|||||LINCOLN ROAD DISTRICT

**HISTORIC PRESERVATION BOARD
REVISED APPLICATION**

05/14/2024

LINCOLN ROAD DISTRICT IMPROVEMENTS PHASE 3

LINCOLN ROAD- 400 BLOCK

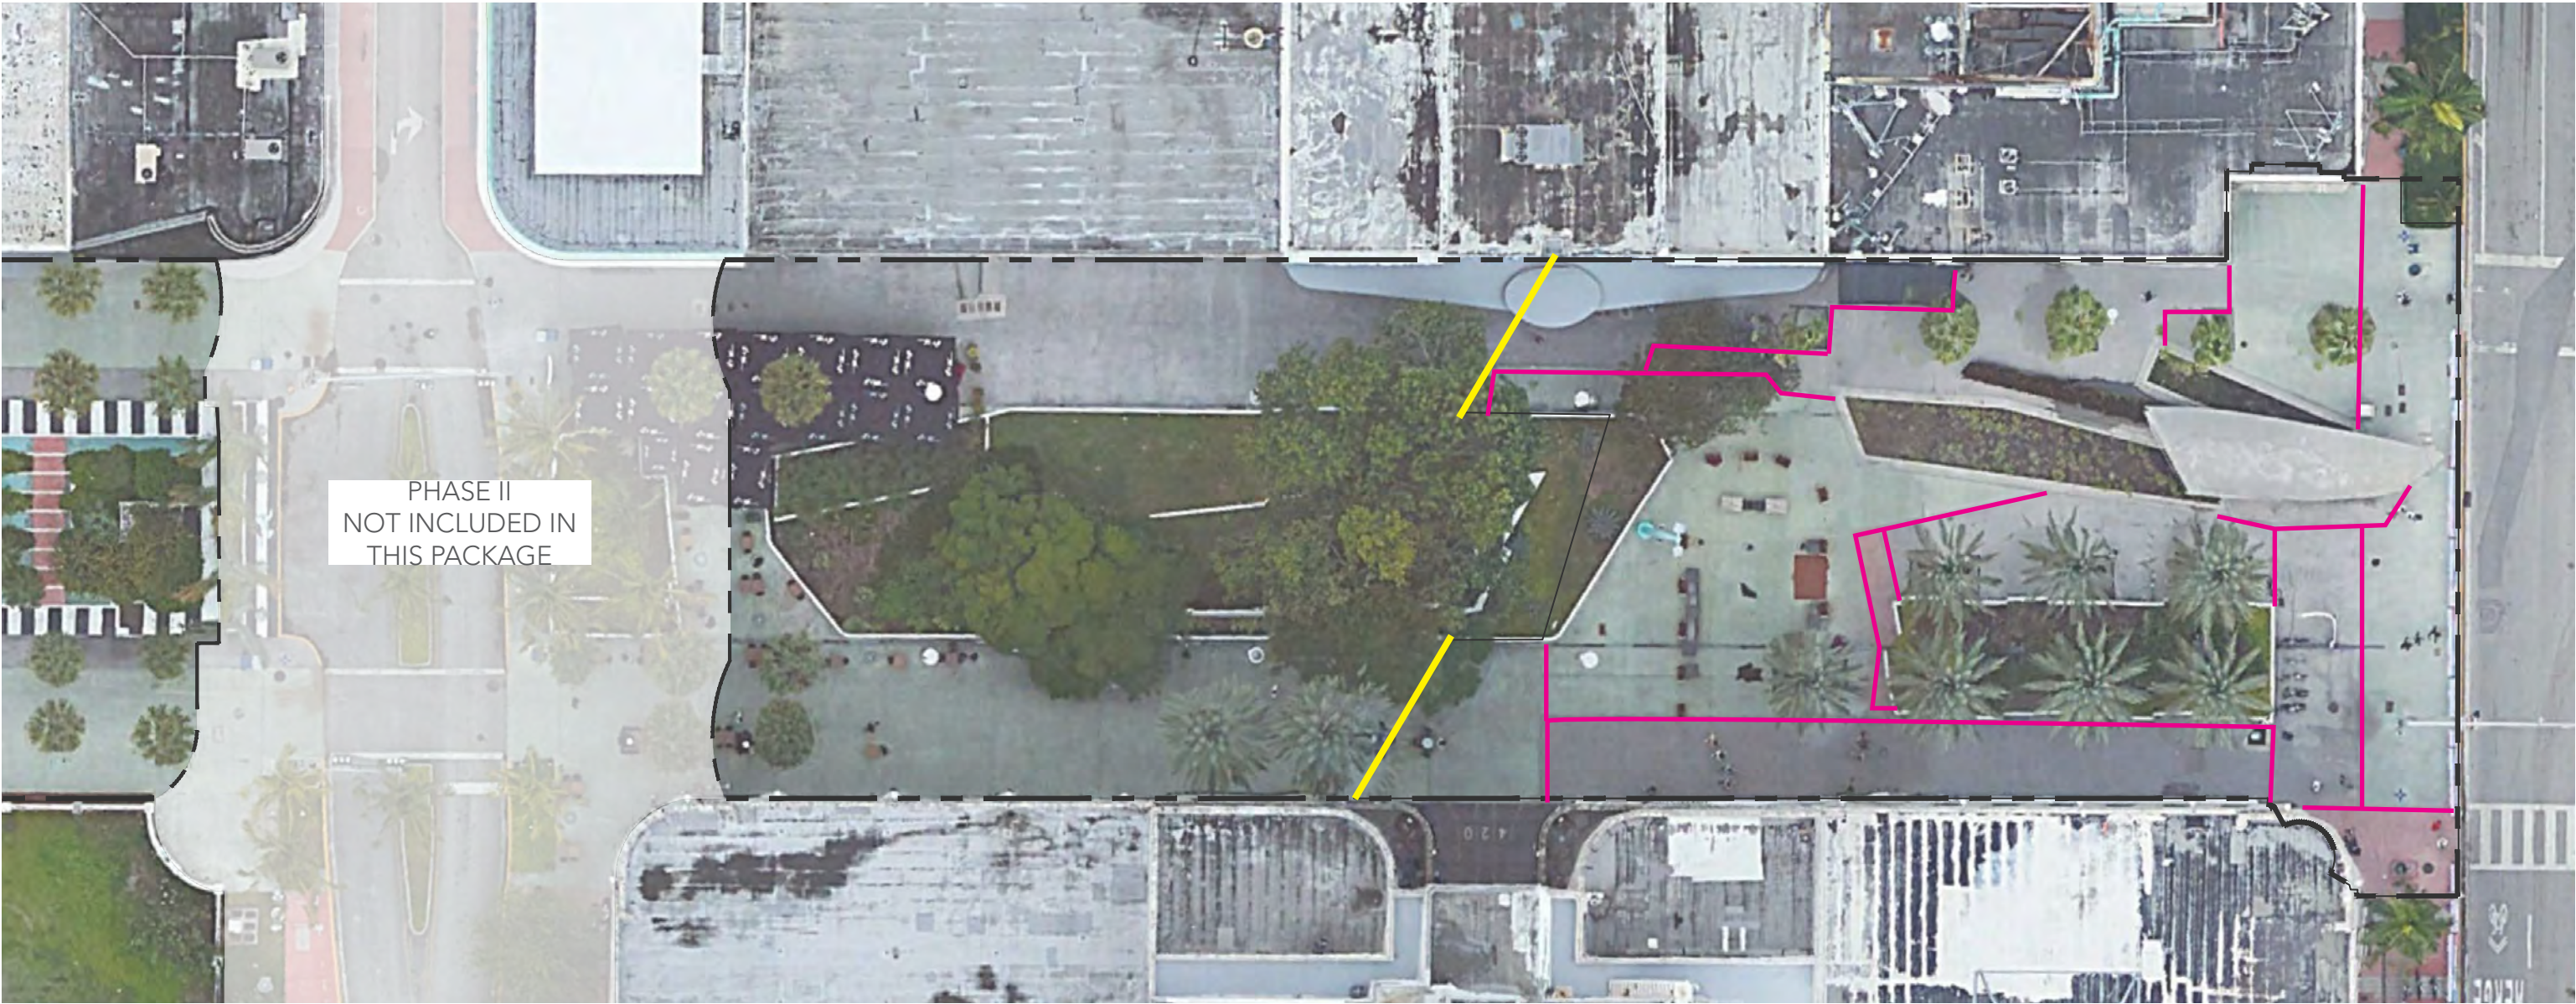
PAVING- REVISIT TRANSITION BETWEEN EXISTING GREEN PAVING TO REMAIN AND PROPOSED NEW PINK PAVING

PLAN PRESENTED ON 02/13/2024

- 1 EXISTING COLORED CIP CONCRETE TO REMAIN
- 2 PROPOSED PINK COLORED PRECAST CONCRETE PAVERS
- 3 PROPOSED BLACK AND WHITE PRECAST CONCRETE PAVERS

REVISED PLAN 05/14/2024

- 1 EXISTING COLORED CIP CONCRETE TO REMAIN
- 2 PROPOSED PINK COLORED CIP CONCRETE
- 3 PROPOSED BLACK AND WHITE PRECAST CONCRETE PAVERS

LINCOLN ROAD- 400 BLOCK
REVISED FURNISHING APPROACH (05/14/2024)

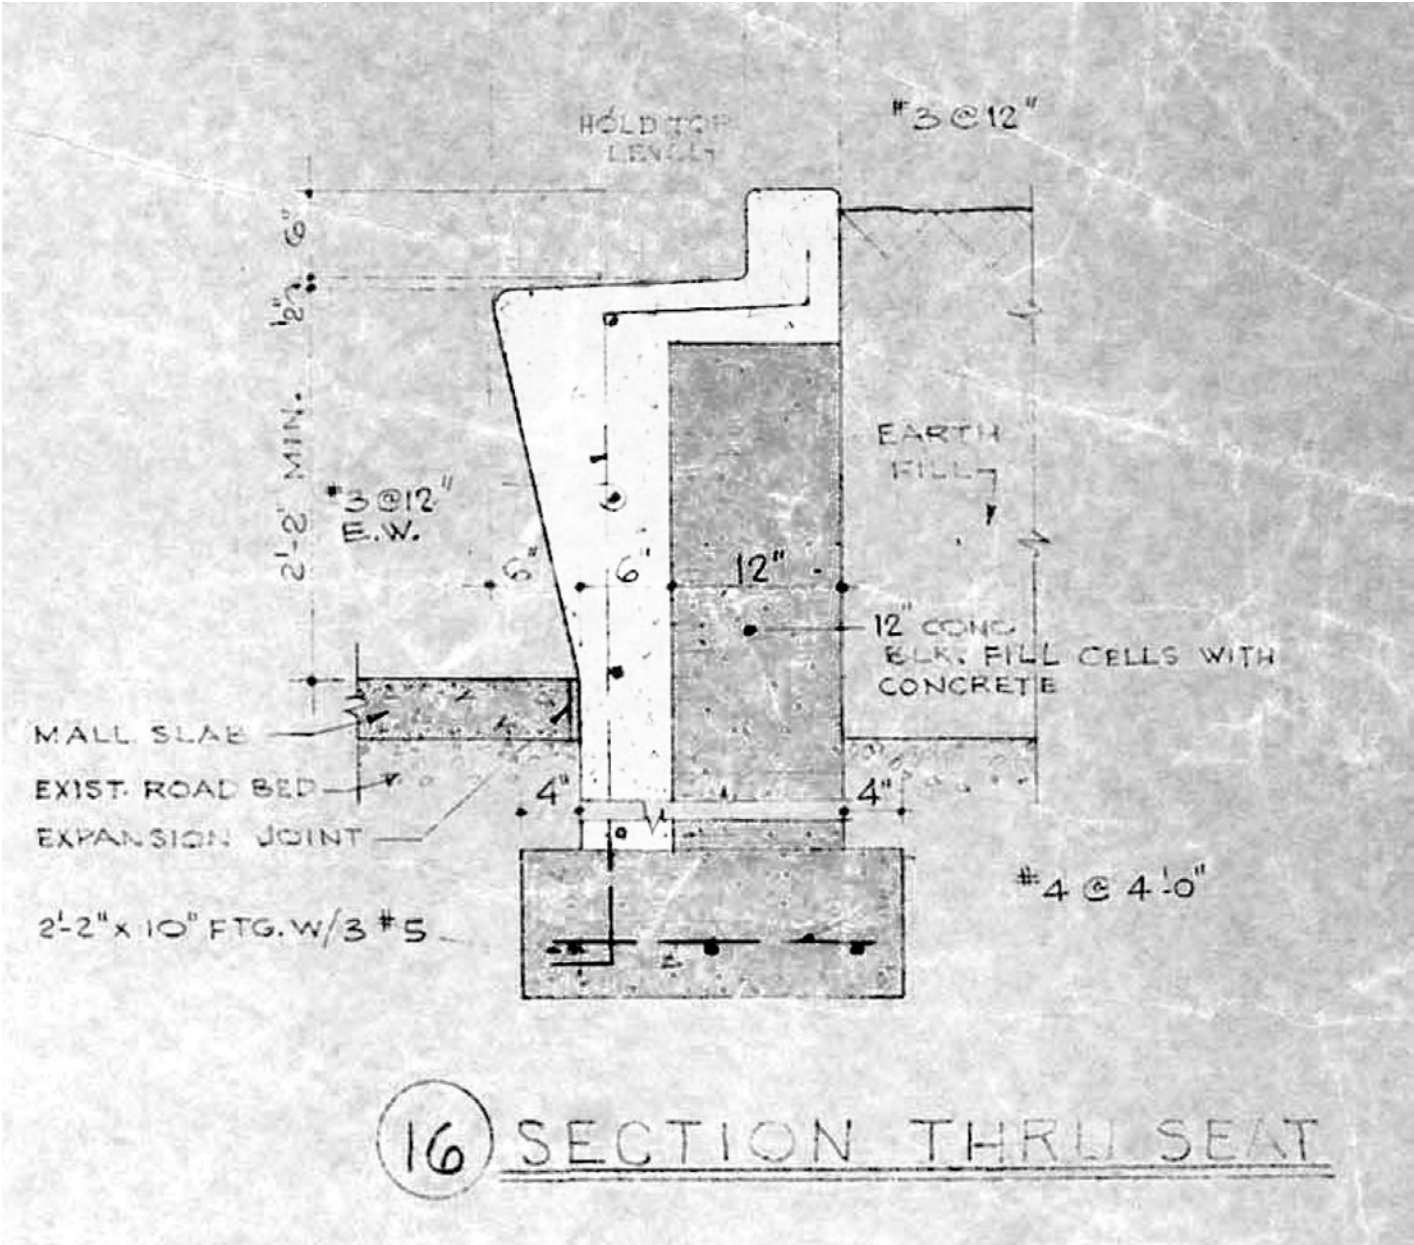
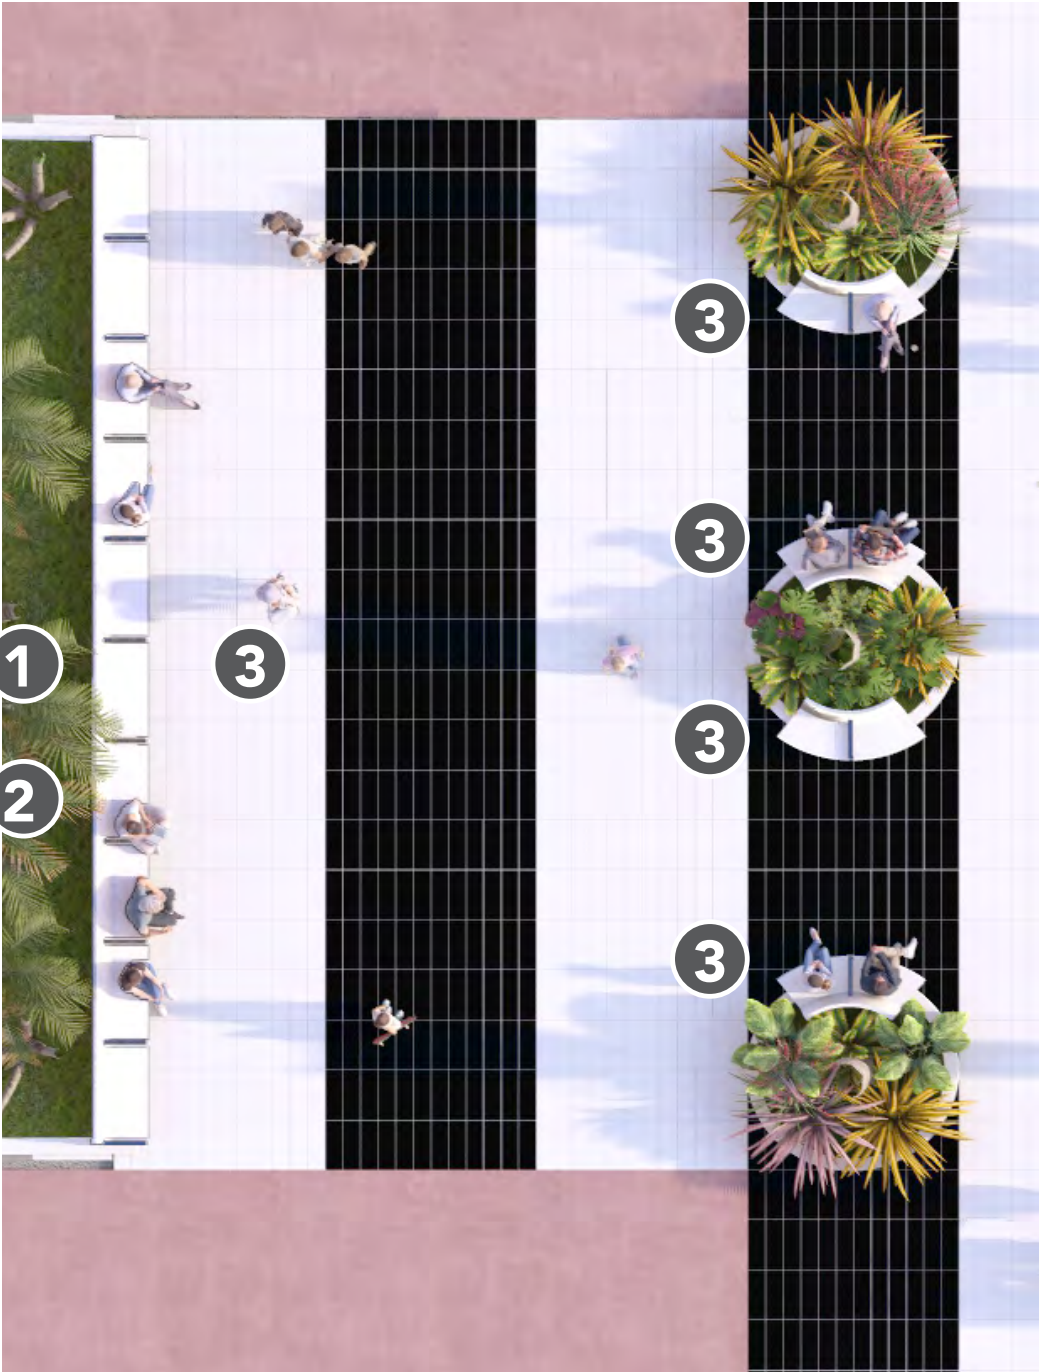
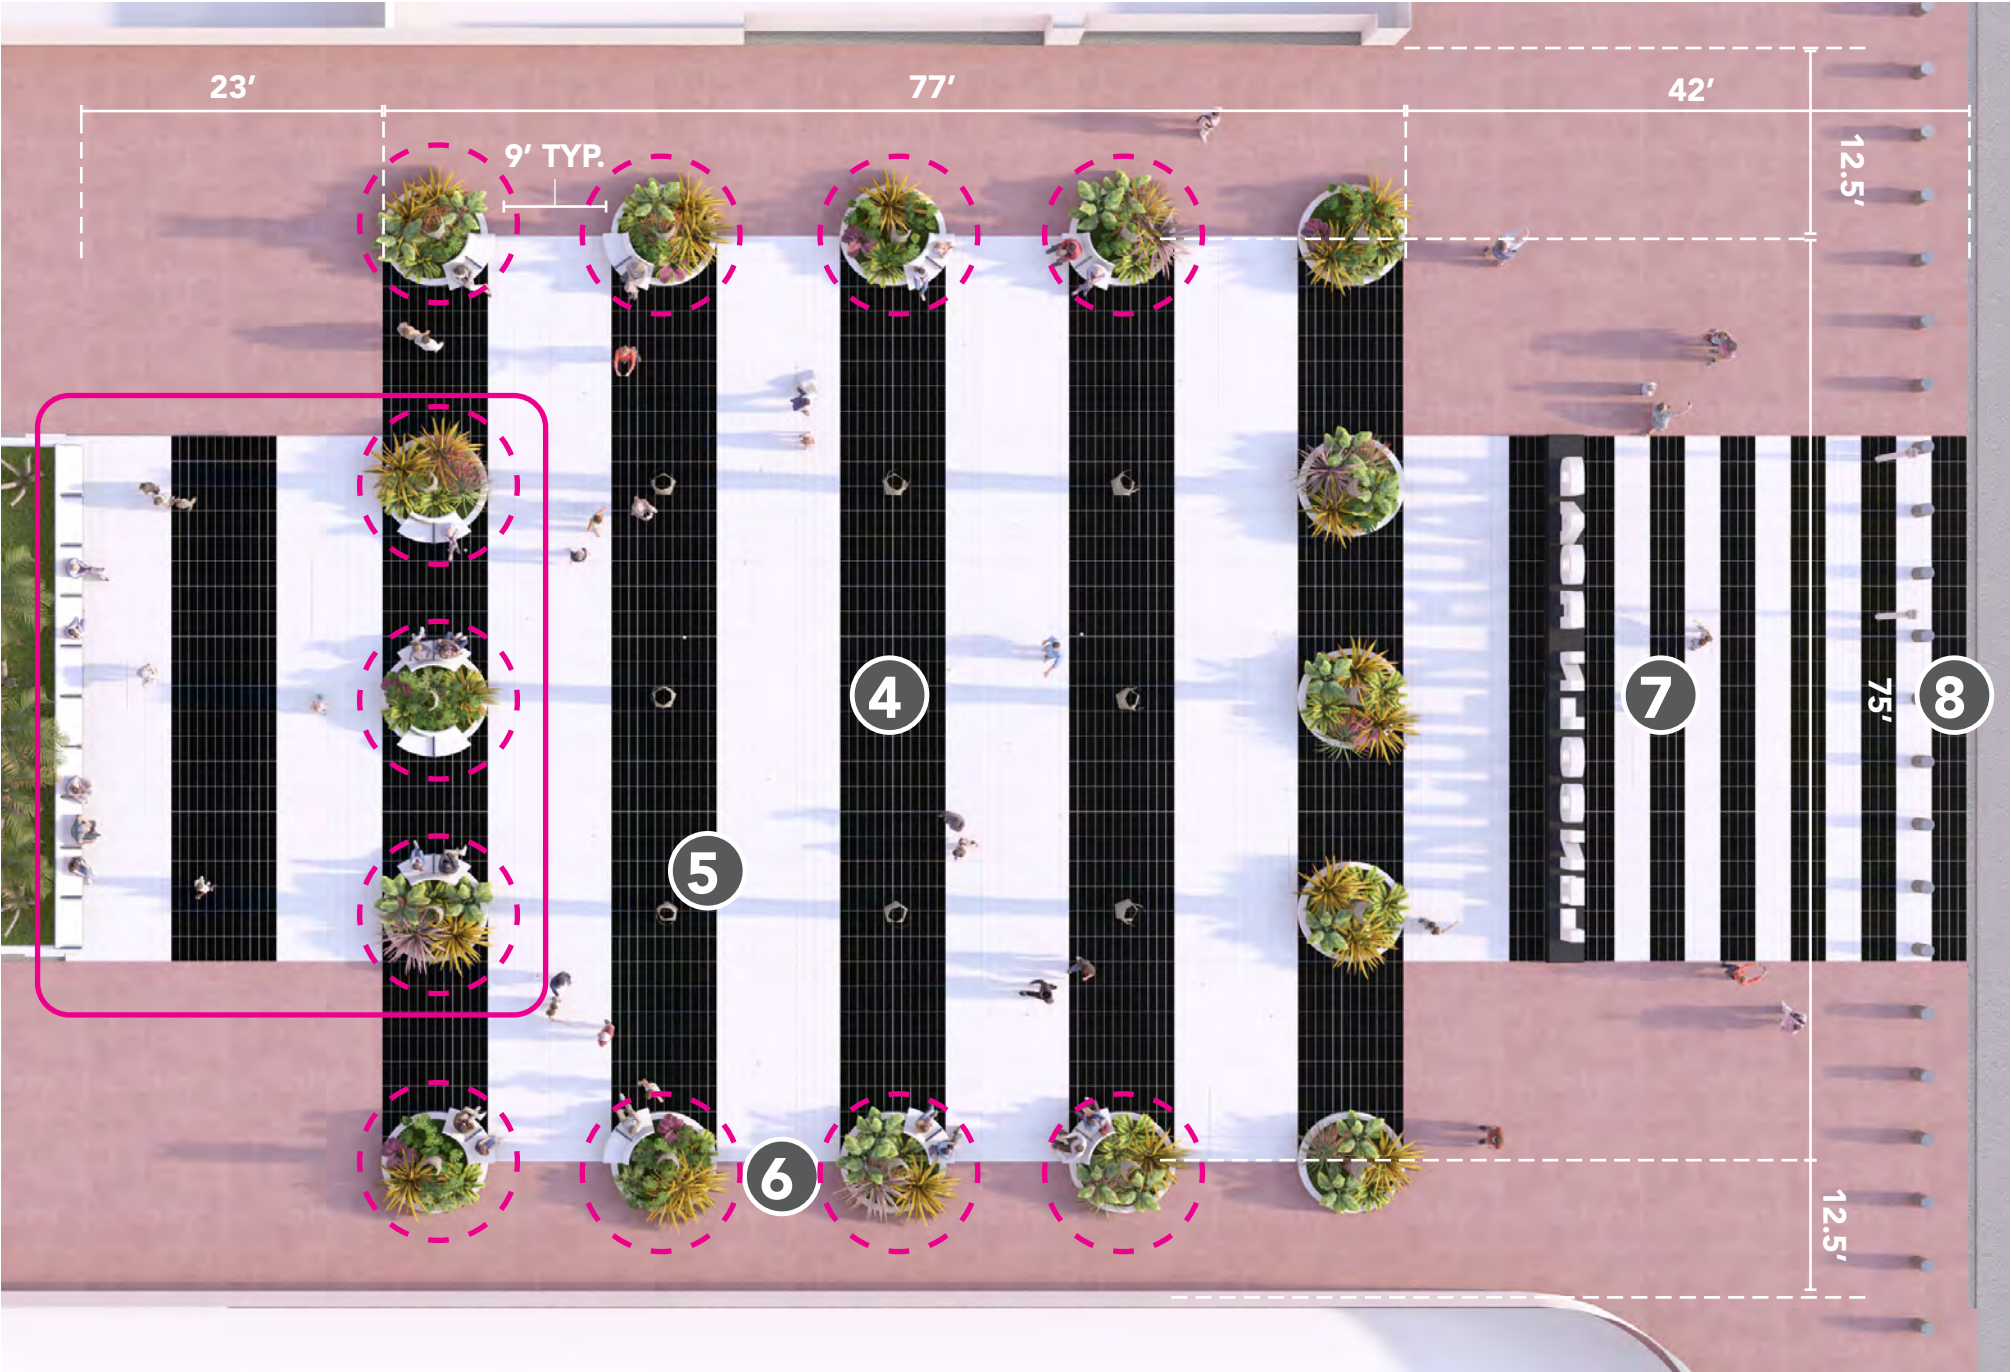
SEATING- PROPOSE ALTERNATIVE TO MOVEABLE SEATING

LINCOLN ROAD- 400 BLOCK
REVISED PLAN WITHOUT CANOPY (05/14/2024)
